Hobson's Conduit Trust

Re CAMBRIDGE SOUTH EAST TRANSPORT ORDER

HOBSON'S CONDUIT TRUST STATEMENT OF CASE

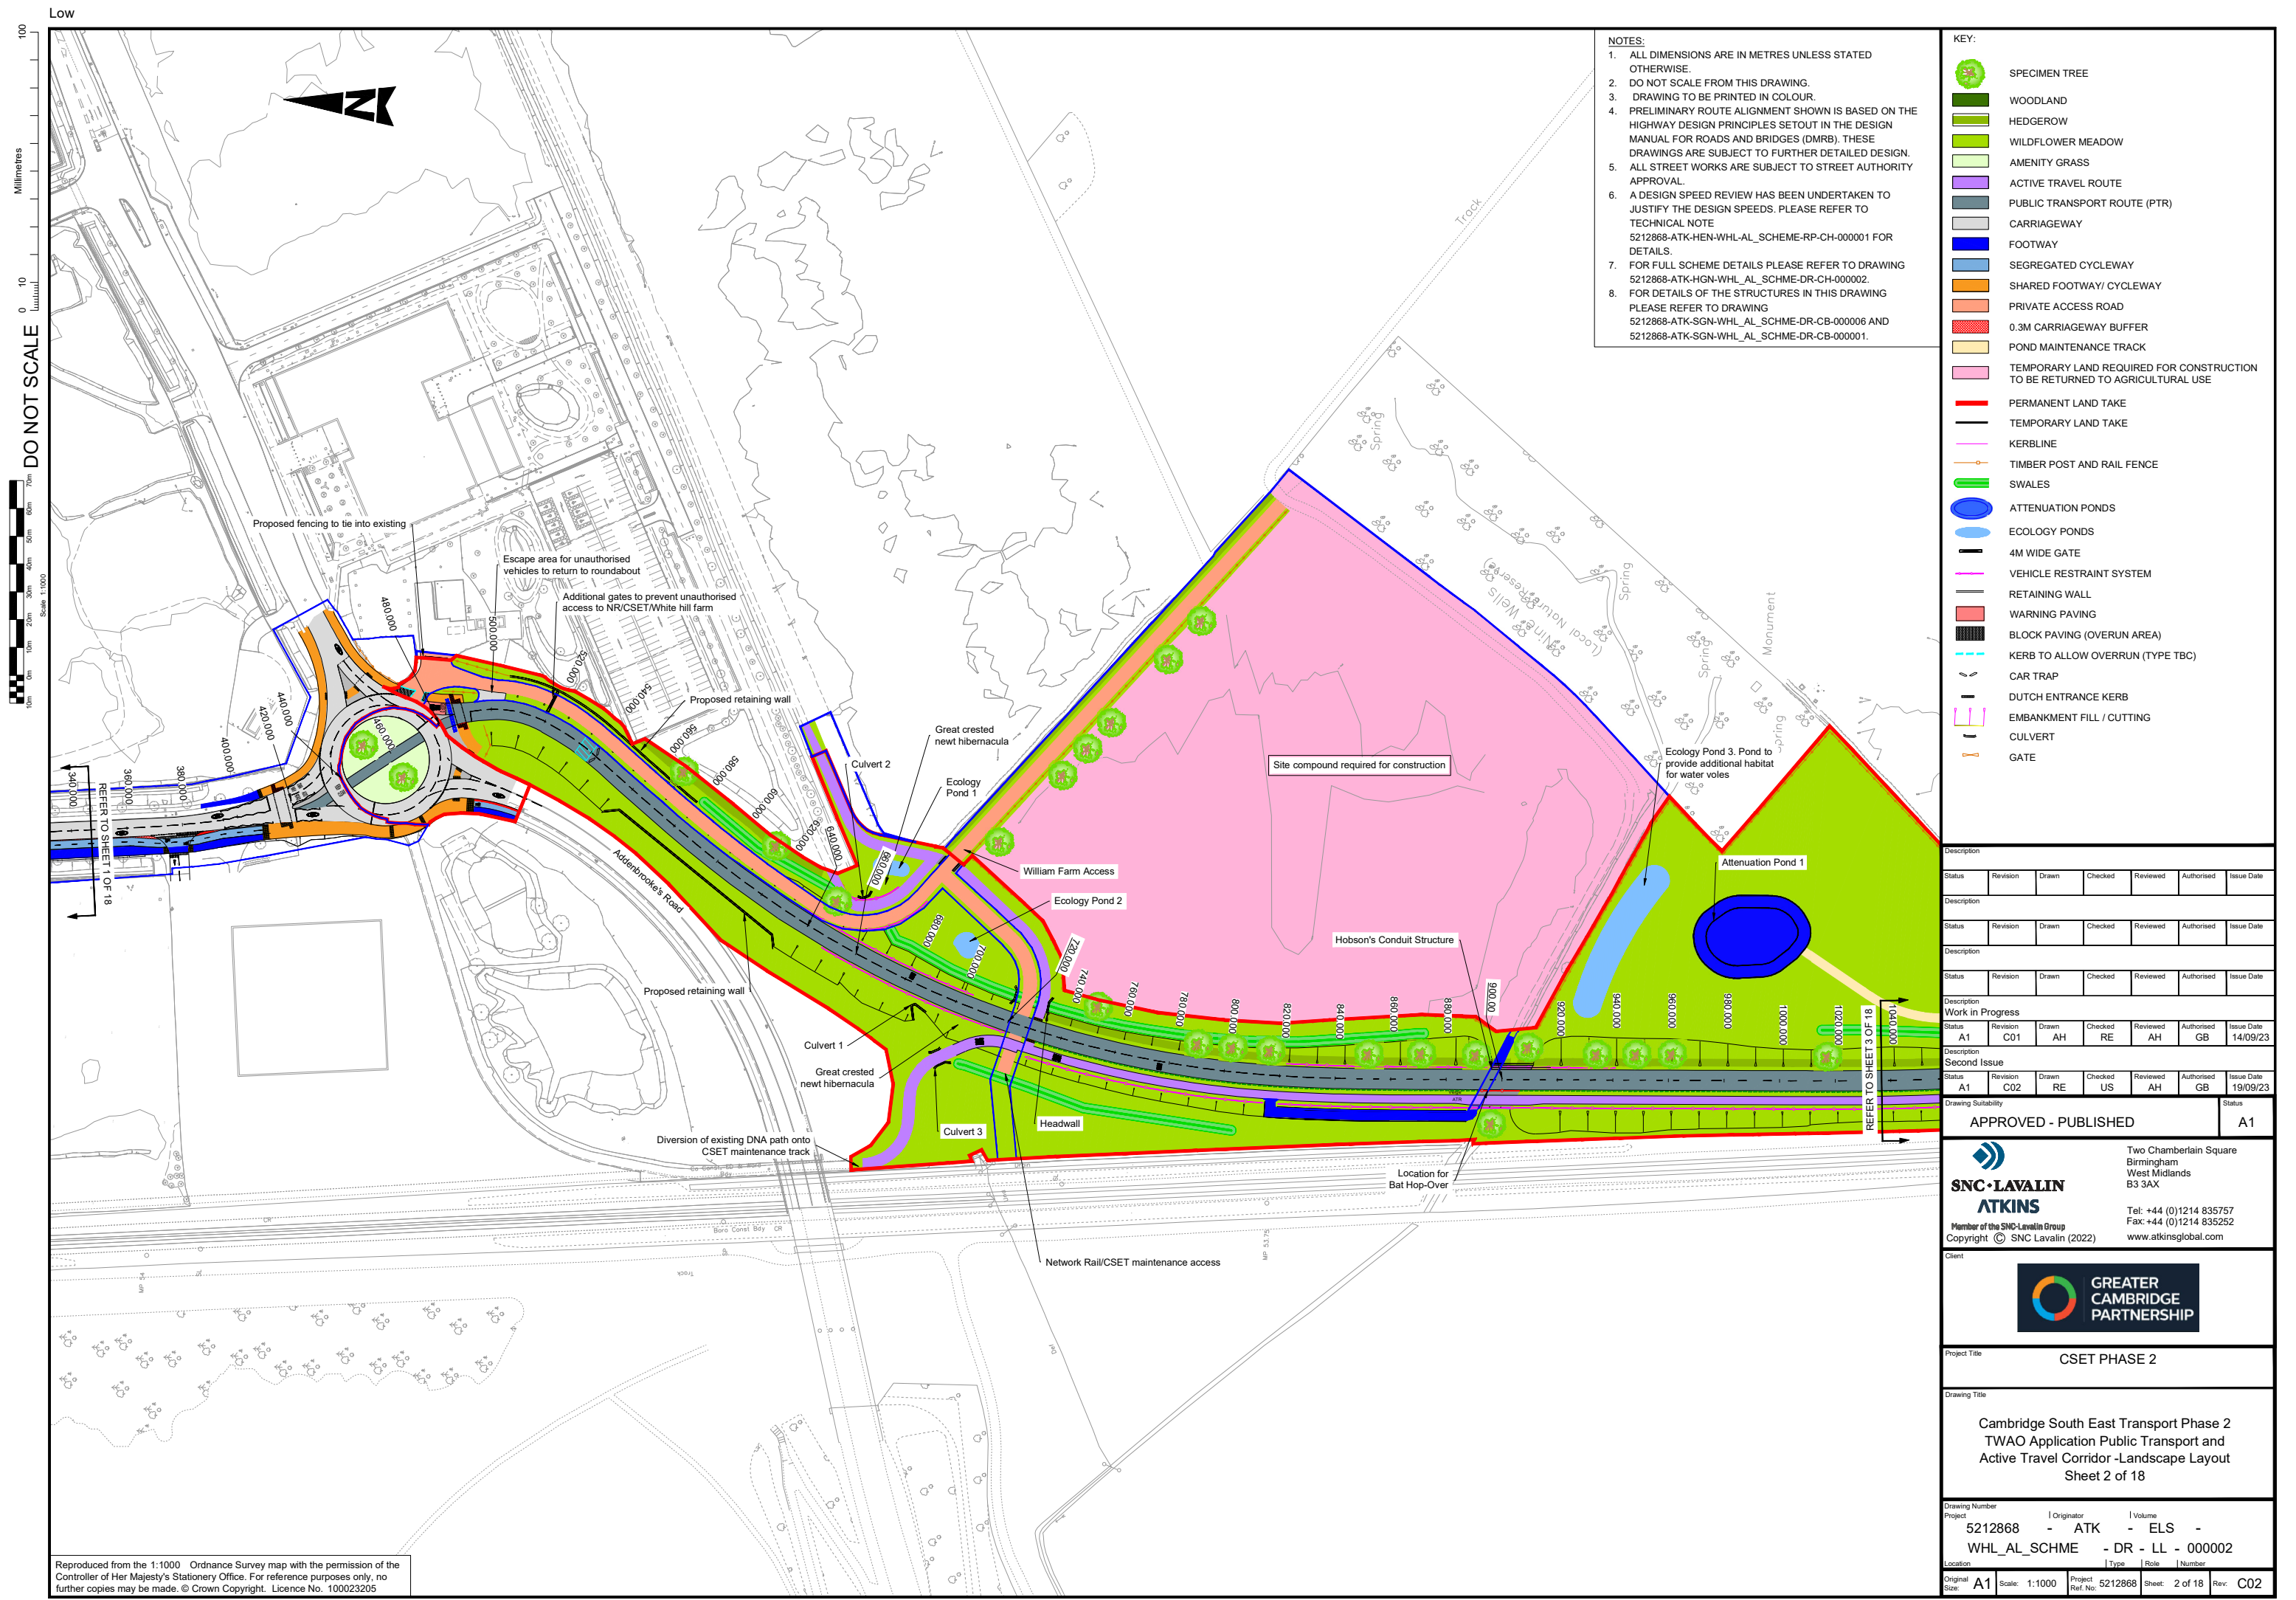
- 7.2.6 In respect of ditch W2, the proposals plans indicate that there will be a culvert of 45m and an additional 2m wide footbridge, resulting in a loss of 47m of ditch W2. Part of the new busway extends over the whole of ditch W8. Proposals (see **Appendix 7**) do not indicate other structures created here so it is assumed that the ditch will be entirely lost. These are both accurately reflected in Atkin's BNG calculation.

Drawing Title
CAMBRIDGE SOUTH EAST TRANSPORT
PHASE 2
STRUCTURE 4 HOBSON'S CONDUIT
GENERAL ARRANGEMENT

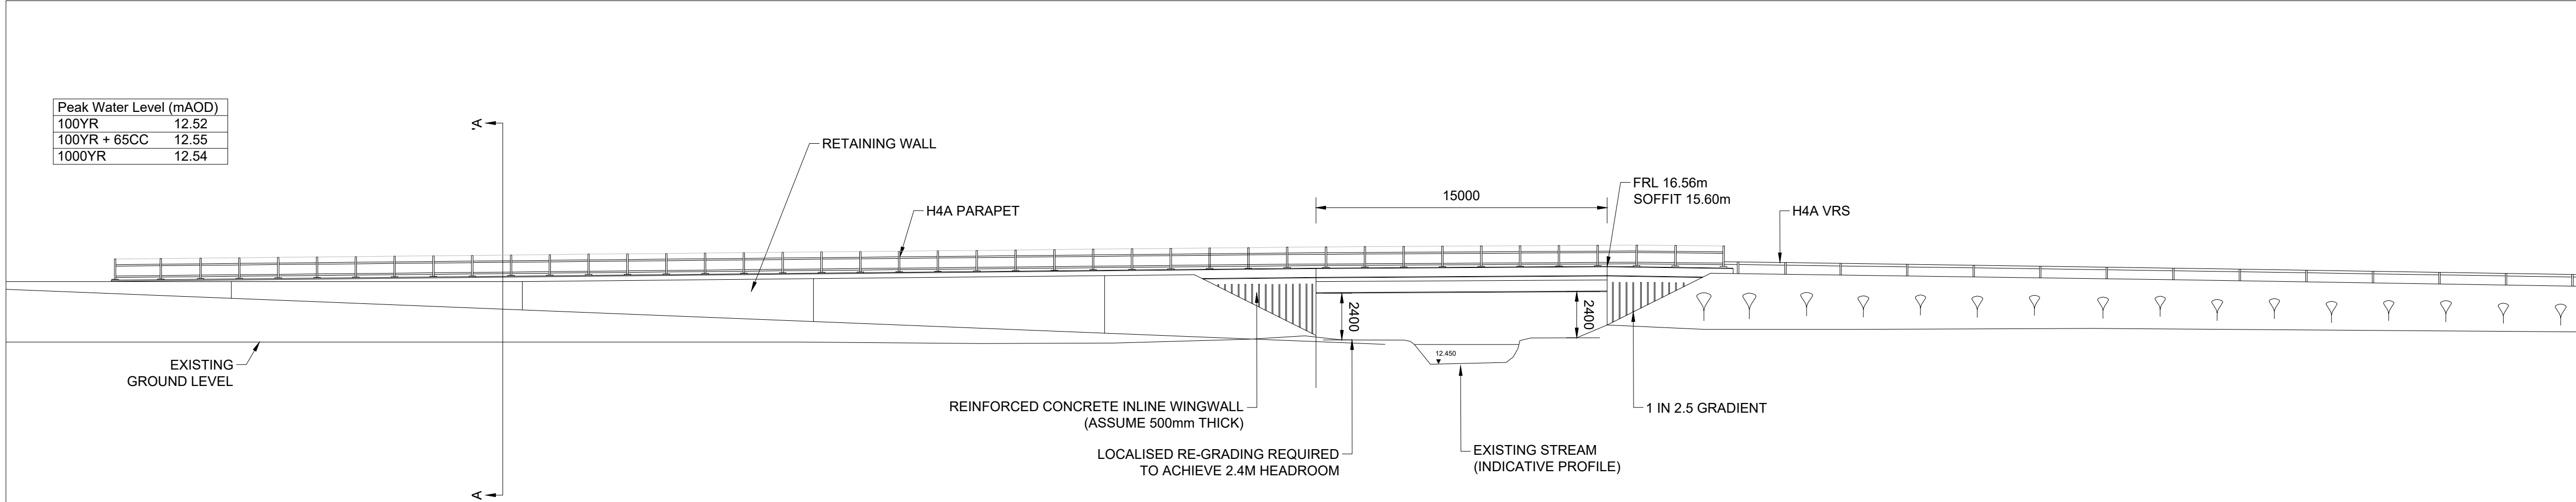
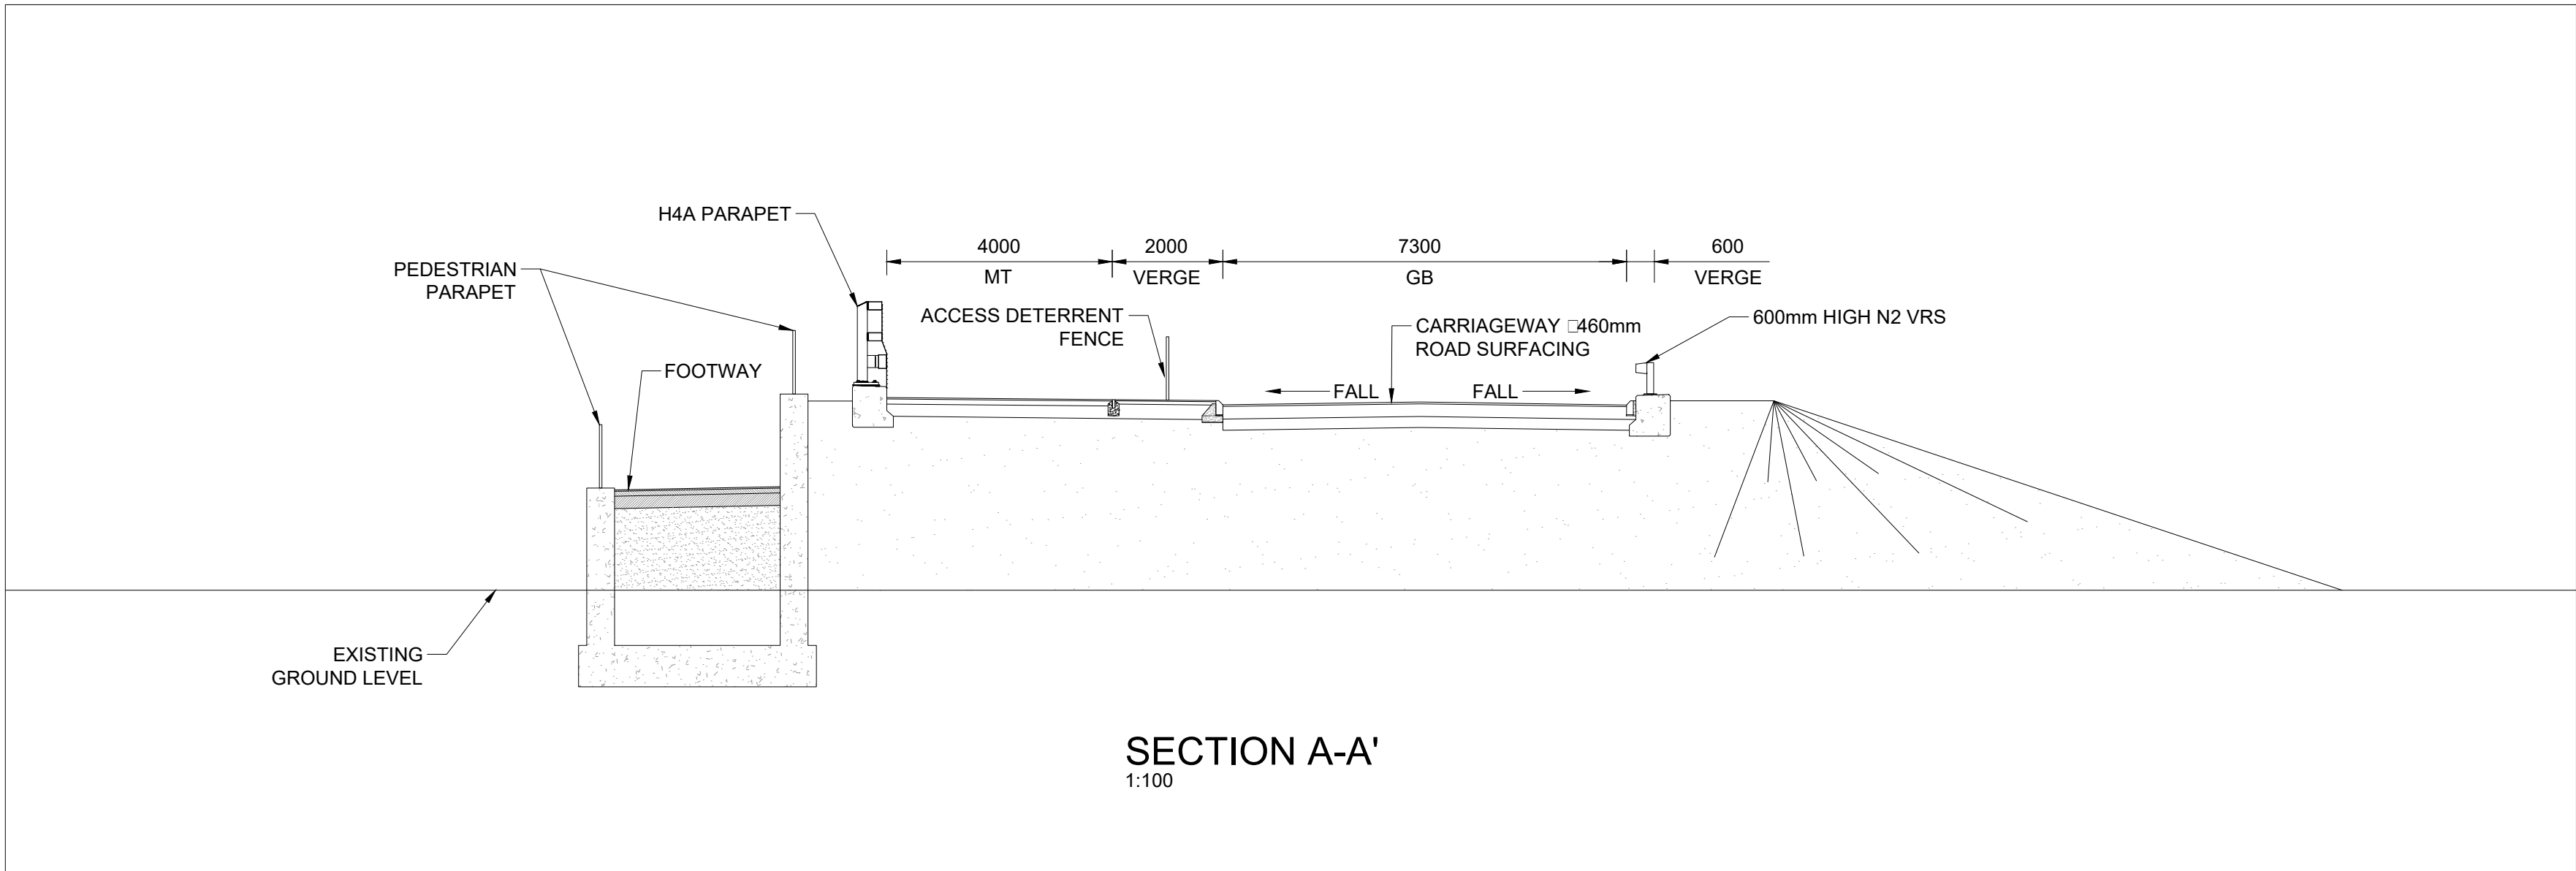
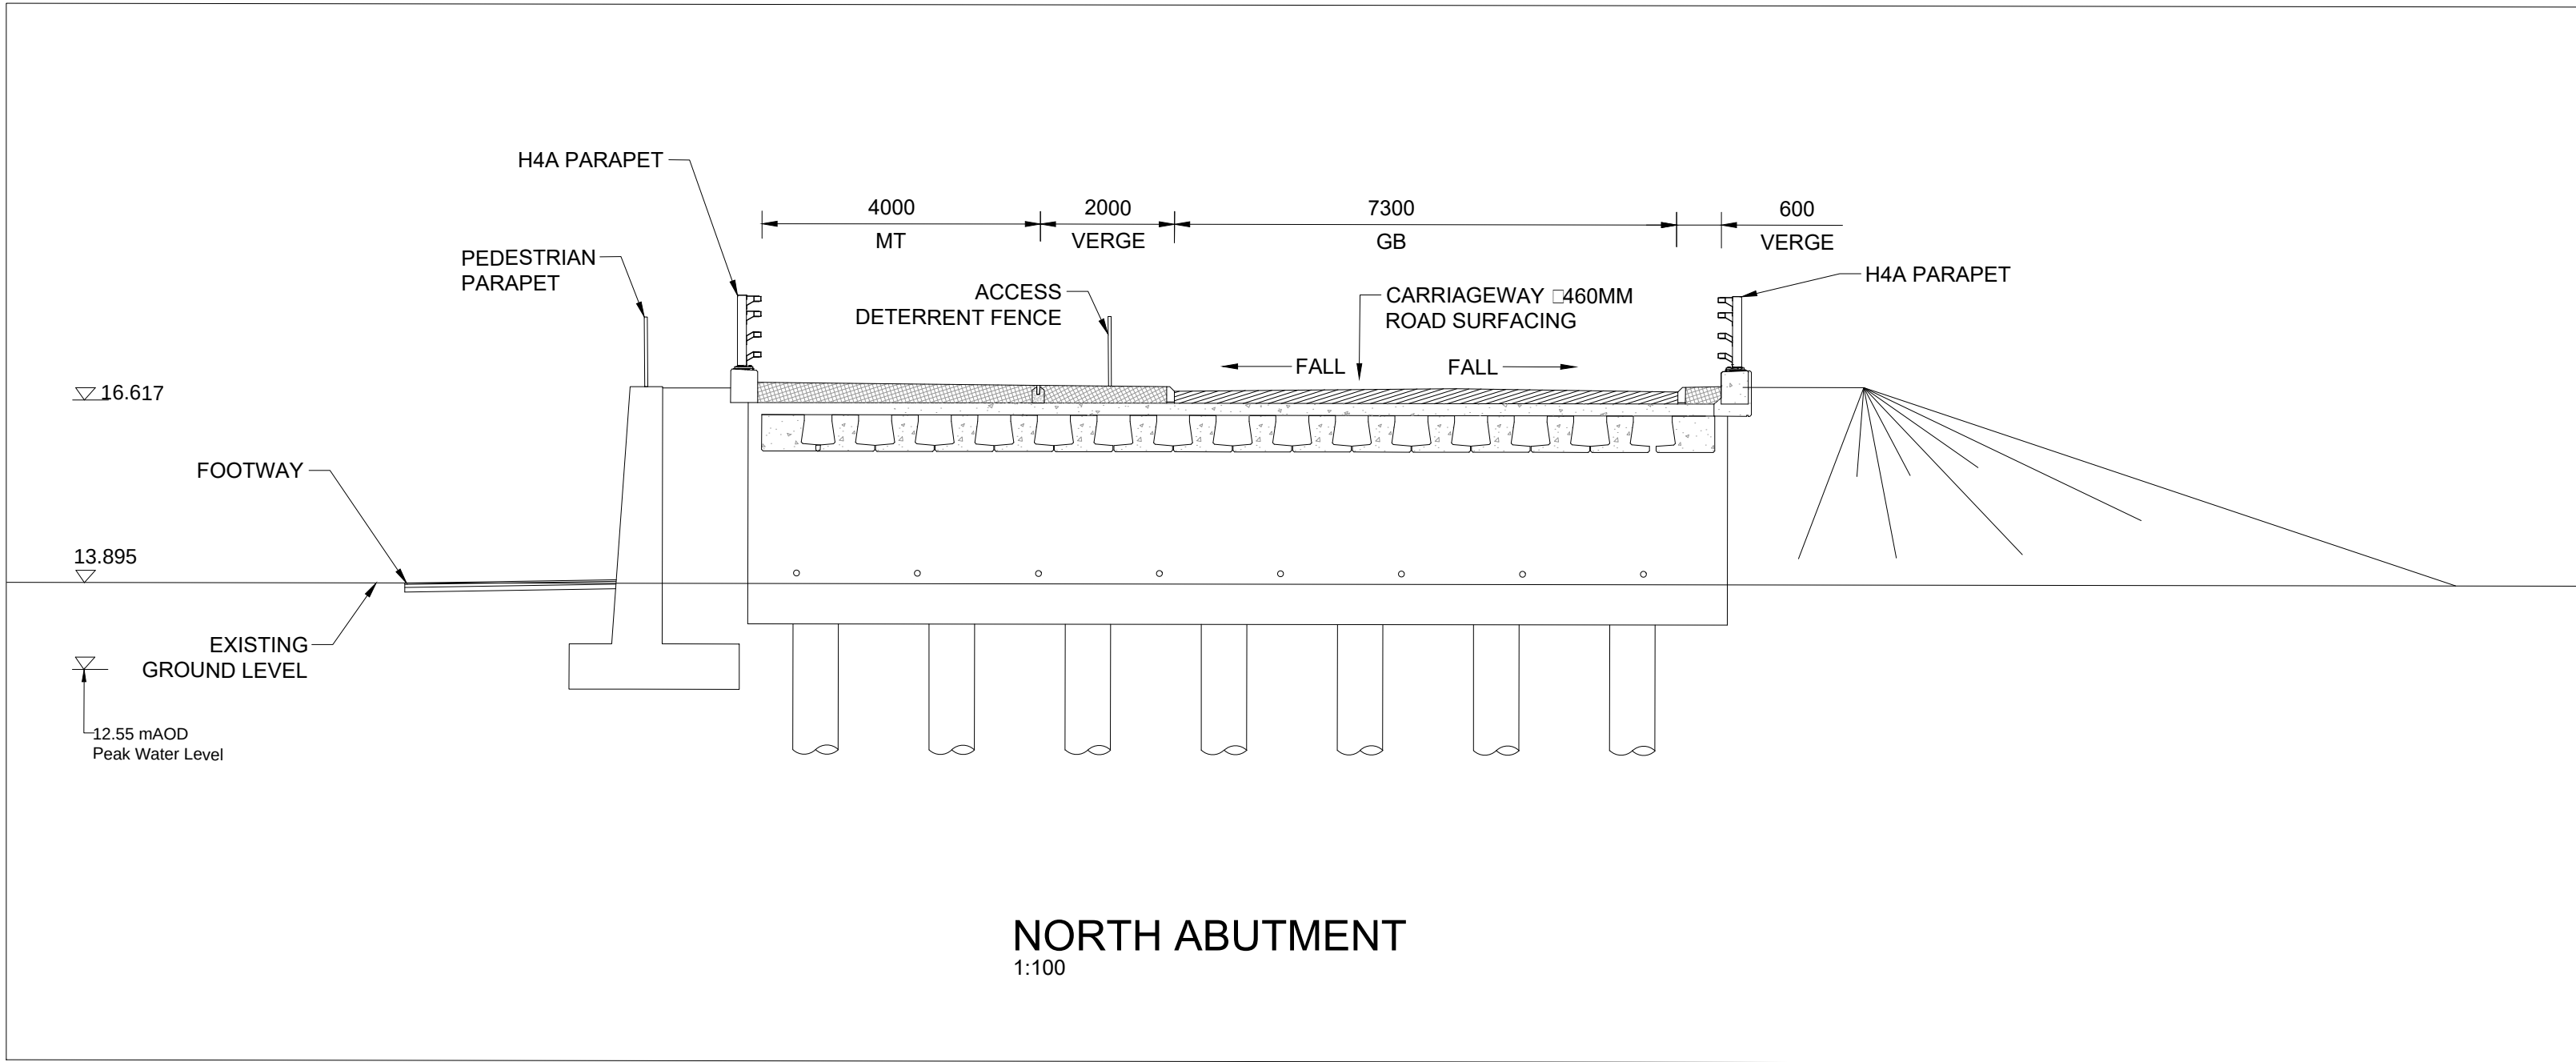
106. HCT requires that careful and thorough research be undertaken to ascertain the effects of the proposed bridge on the ecology of Hobson's Brook, its margins and the airspace above it. Were the results to show that the effect would be harmful, HCT would wish to see a redesign of the bridge, ideally splitting it into two bridges each of smaller width (for the busway and the multi-user path separately), to reduce or eliminate the harm.

with galvanised steel crash barriers both sides of the busway, and a steel fencing safety barrier along the concrete 2 metre safety verge across the bridge deck. Mitigation planting of screening trees on and around the busway's embankments has been proposed, together with a new hedgerow to be planted along the top of the embankments on the eastern side, visible from Nine Wells (VP 6). However, on at 11.8.3 (p 228) of the Environmental Statement the applicants seek to convey that the landscape impact at Nine Wells will no longer be moderate adverse and significant. We object to this assessment and its implications.
